RETAIL ENERGY CODE

CHANGE REPORT

R0083 – CHANGES TO SUPPLY NUMBER FORMAT FOR MHHS

CHANGE REPORT	PRELIMINARY
DOCUMENT VERSION	2.0
ISSUED DATE	07/06/2023
DOCUMENT APPROVAL STATUS	APPROVED

8.1 PROPOSED SOLUTION FOR ORIGINAL CHANGE PROPOSAL - R0083

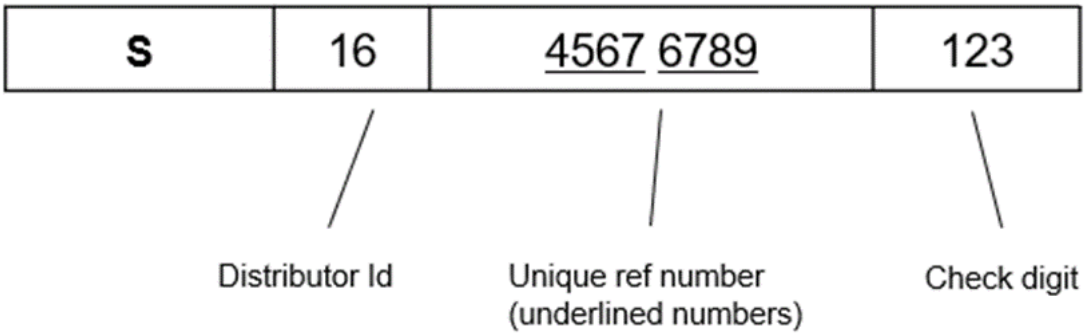
The proposed solution that the Code Manager is taking forward to consultation is Option 1, as it has been presented for impact assessment. The solution documentation has, however, been enhanced to provide greater clarity on the approach to implementation.

The following example has been included for illustrative purposes:

The draft legal text has been updated to include an additional example to demonstrate where data items are not applicable. The updated version of the draft legal text for R0083 can be found here.
